# Access Compliance Report

## Public Rights-of-Way

Intersection ID: 32023	Main Street: CORNWALLIS_CAMP_DR	Cross Street: WESSYNTON_DR	Location: NE
ADA ID: 7D18446C0100	Ramp Type: PerpDiag	Initial Pass/Fail: Fail	Overall Compliance: No
Codes/Mitigation Info/Possible Solution		Field Measurements/Component Compliance

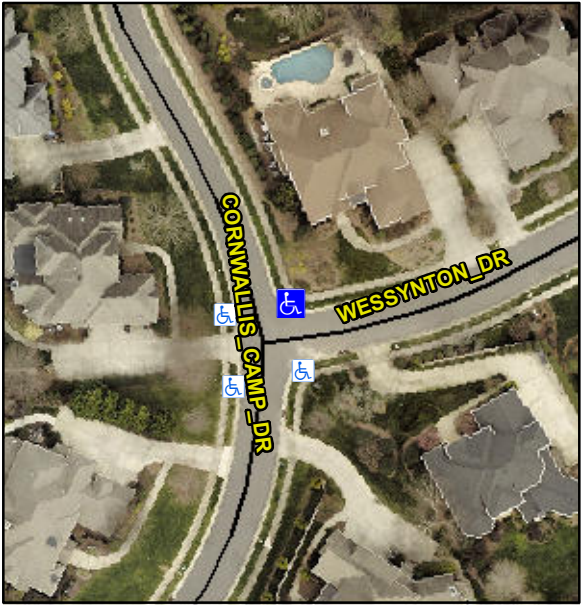
Possible Solutions:	Compliance	Description	Data	Compliance	Description	Data
	Remove & Replace Curb Ramp With Two New Directional Ramps or Equivalent.	N/A	Ramp Length (in)	48.0	No	Ramp Slope (%)	8.5
<p>Surveyor Notes:</p> <p>N/A</p> <p>PROW/ADA:</p> <p>Not Found, R304.5.1, R304.2.2, R304.5.3</p>		No	Ramp Width (in)	35.0	No	Ramp XSlope (%)	2.5
		N/A	Flare Type LT	N/A	N/A	Flare Type RT	N/A
		N/A	Flare Slope LT (%)	N/A	N/A	Flare Slope RT (%)	N/A
		N/A	Flare Traversable LT?	N/A	N/A	Flare Traversable RT?	N/A
		N/A	Landing Length (in)	N/A	N/A	DWS Provided?	N/A
		N/A	Landing Width (in)	N/A	N/A	DWS Contrast?	N/A
		N/A	Landing Slope (%)	N/A	N/A	DWS Length (in)	N/A
		N/A	Landing X Slope (%)	N/A	N/A	DWS Full Width?	N/A
		N/A	Landing Curb? (Y/N)	N/A	N/A	DWS Offset (in)	N/A
		N/A	Shared Landing?	N/A			
		N/A	Gutter Ponding?	N/A	N/A	Gutter Slope (%)	N/A
		N/A	Gutter Lip Ht (in)	N/A	N/A	Gutter X Slope (%)	N/A
		N/A	Painted X Walk1?	No	N/A	Painted X Walk2?	No
